Shenstone Park PSP

Separation Distances for Dust and Odour

28 October 2020

Project No.: 0568335

Figure 3-1 Separation Distances within the Shenstone Precinct Structure Plan (Victorian Planning Authority, 2020)

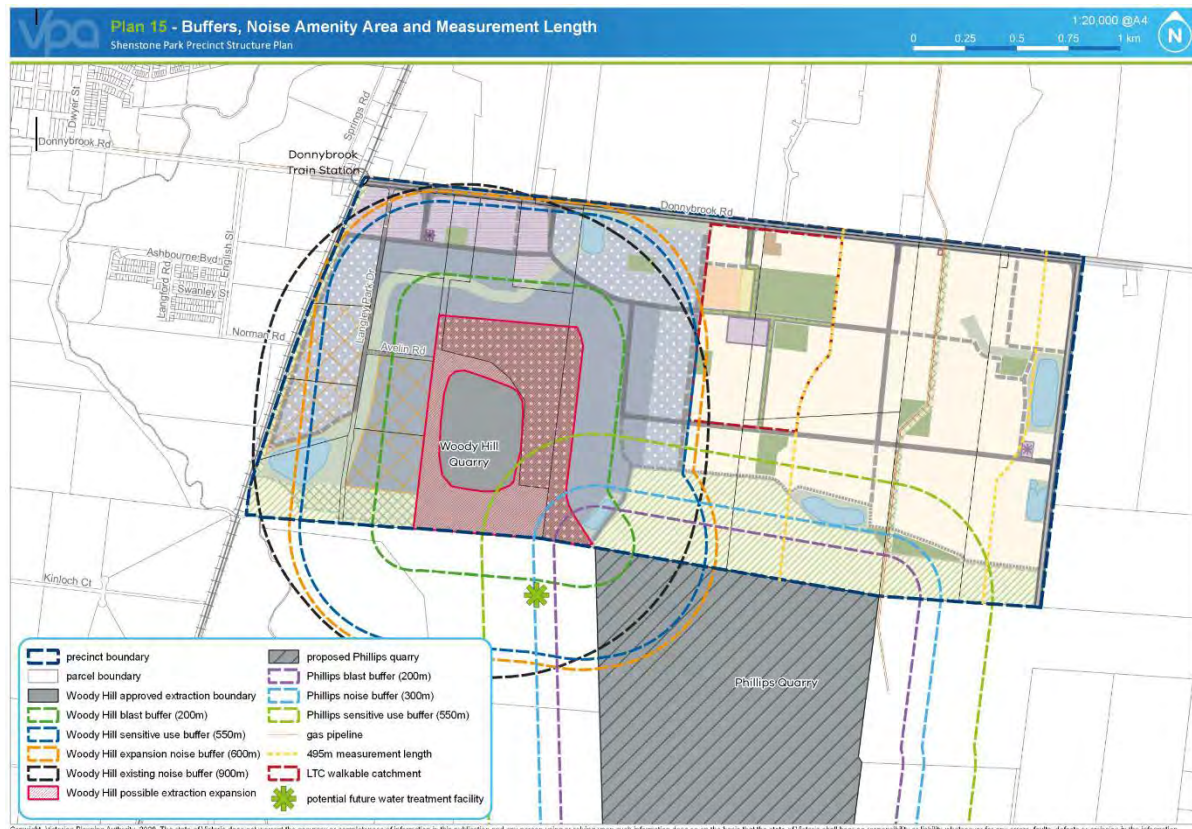
As outlined in Section 5 of this assessment however, there are concerns with the approach adopted by the Victorian Planning Authority consultants in defining the appropriate separation distances in relation to dust impact, due to their understanding of potential future activities and a more robust approach in accordance with the requirements of EPA Publication 1518 is required.

Figure 5-1 Comparison of GHD wind rose (left) and that prepared for this study (right)

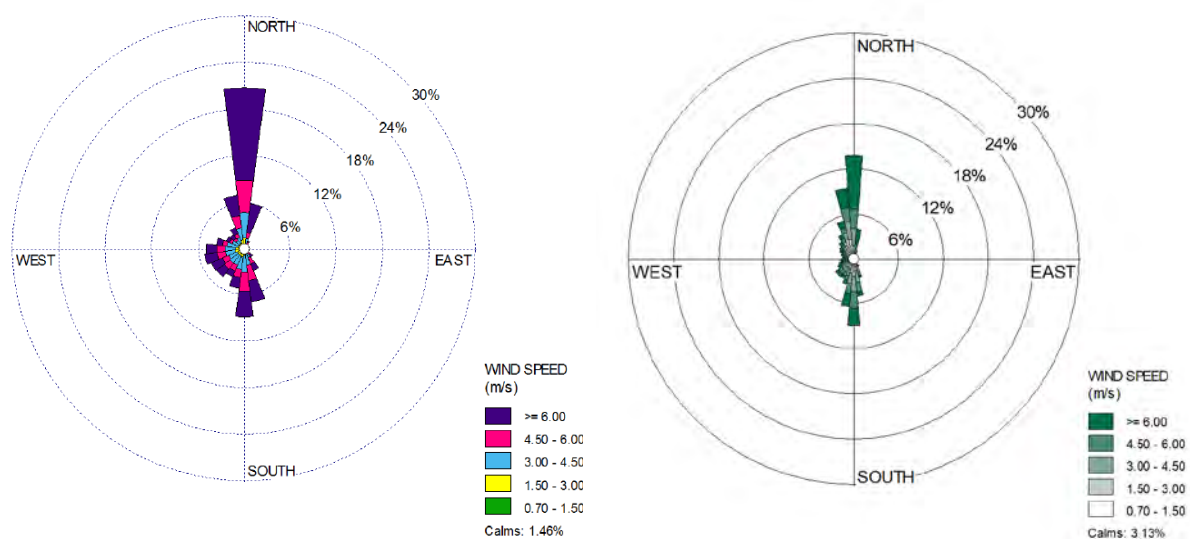
Figure 5-1 provides a comparison of the windrose generated by GHD for the period 2012 to 2016 from Melbourne Airport with surrounding land use being scrub land, and that derived for this study for the period 2015 to 2019 using meteorological modelling and the proposed land use characteristics.

From a comparison of these wind roses, it can be seen that it is likely that GHD's approach has under estimated the frequency of calms (less than 0.7 m/sec) and over estimated the frequency of the elevated wind speeds, especially from the north. In addition, the frequency of the winds from the south-west appears to be over represented in this location and that winds from the SW direction occur nearer to 3% of the time than 6% of the time.
